Subject: DA 2022 1425; 132A Queens Parade East Newport 2106 WRITTEN SUBMISSION: LETTER OF OBJECTION SUBMISSION: BOSHER

RE: DA 2022 1425; 132A Queens Parade East Newport 2106

WRITTEN SUBMISSION: LETTER OF OBJECTION

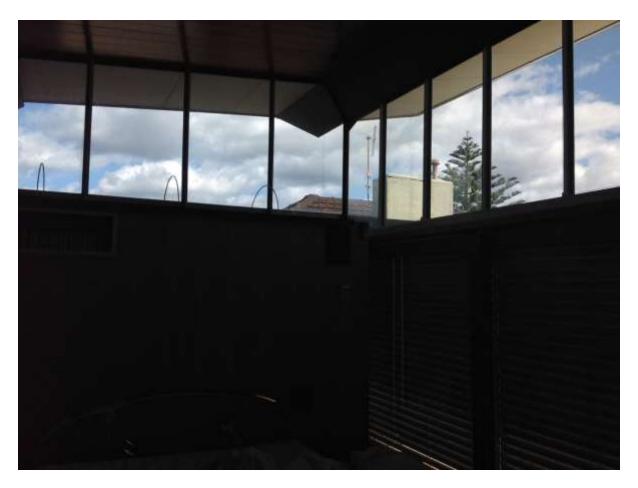
Comment: As the development is considered to result in an unacceptable privacy impact due to the design, it is requested that the proposed development be redesigned to reduce amenity impact on the neighbouring properties.

In the context of the above principles, the application can be considered to violate the reasonable expectation that the habitable rooms and private open space at our property will remain private. It is therefore reasonably anticipated that the application does not comply with the DCP.

The above non-compliance will give rise to unreasonable amenity impacts upon the adjoining properties. In this instance, the proposal is not considered to achieve compliance with this control.
